Title Cover Unit Retainer Strip			
Drawn By JFR	Dir\Filename T5842.dwg	Issue Rev A1	Total Pages 1
Origin Date 4/12/13	Part Number T5842	Revision Date 5/17/01	Page Number 1
Fun Projects, Inc.			
PROPRIETARY- Information presented in this document is the Property of Fun Projects, Inc. and is not to be reproduced or distributed without specific written permission.

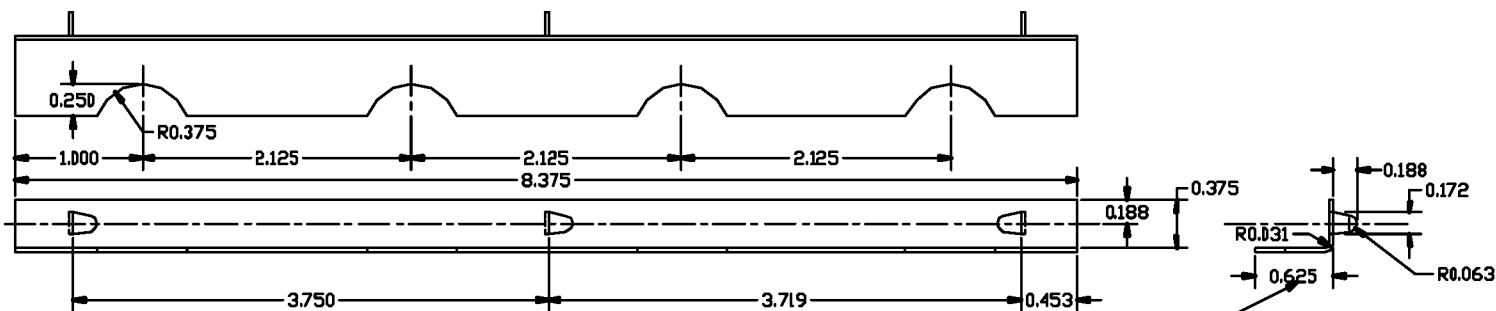
←.625/.641 beginning 4/7/15

3/11/20 - Ledge which fits on coil unit is bent down at 10 degree angle

5/4/22 - Flange width changes from .625/.641 to .719/.750 and  
 depth of notches from .250 to .344

Remained virtually unchanged from 5/4/22 till end of production

Was not used on '26/'27 car but was used on TT for '26
